# A d d e n d u m

Iowa Department of Transportation  
Office of Contracts

<b>B.O.</b>	<b>Proposal ID</b>	<b>Proposal Work Type</b>	<b>County</b>	<b>Project Number</b>	<b>Addendum</b>
018	97-C097-099	Bridge and Approaches - CCS	Woodbury	BROS-C097(99)- -5F-97	19apr018.a01

2P\_  
MODIFIED

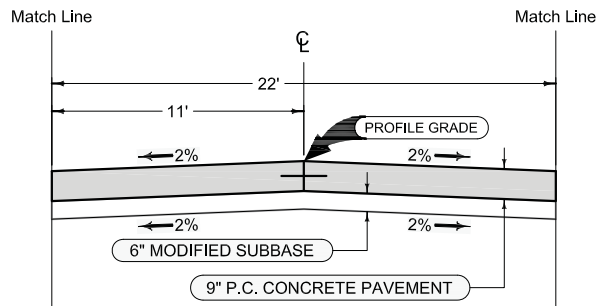
SHEET C.05:

Replace Typical 2P\_ with the attached Typical 2P\_

STATION TO STATION	
14+00.00	15+63.87
17+57.33	19+00.00

Mainline Jointing:  
Transverse joints: CD at 20' spacing  
Longitudinal joint: L-2
